Re: **Trask River RV Park (PWS #[95561](#)) - Well #1 (St Card #1060581, [TILL53275](#))  
Site Plan Approval ([PR #54-2023](#))**

Trask River RV Park (PWS #95561) – Well #1 (L148793) Site Plan Approval LTR (PR#54-2023)  
April 27, 2023

**Evaluation Results From Regional Hydrogeologist:**

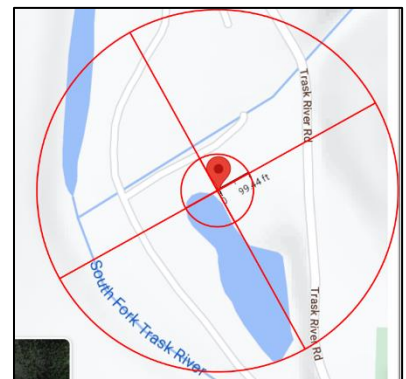
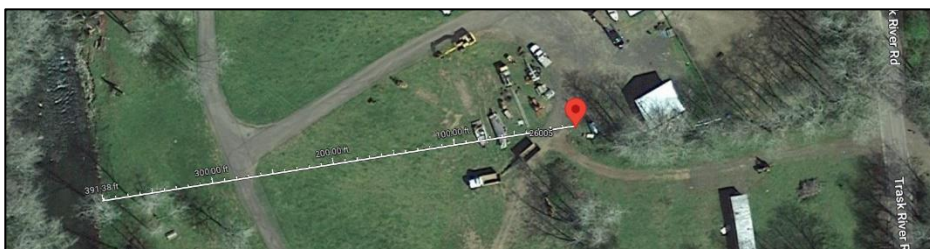
Estimated depth to water-bearing zone: 25 to 75 ft

Estimated aquifer nature:  Confined       Unconfined

Estimated depth of casing seal: 18 ft minimum, deeper depending on depth to bedrock.

Comments: Based on well logs for existing wells within Township 1 S., Range 8 W., Section 36, the water-bearing zones in this area are associated with the bedrock that underlies the surface deposits. Water within the bedrock is likely restricted to fractures with the depth to the first water-bearing fracture likely within 25 to 75 ft of the surface. The water-bearing fractures appear to display a confined condition with water-levels rising above the point at which water is first encountered. Final interpretation of the aquifer condition will be determined after a well log has been submitted for review. The depth of the casing seal should be determined based on materials encountered during drilling in accordance with Oregon Water Resources Department well construction standards.
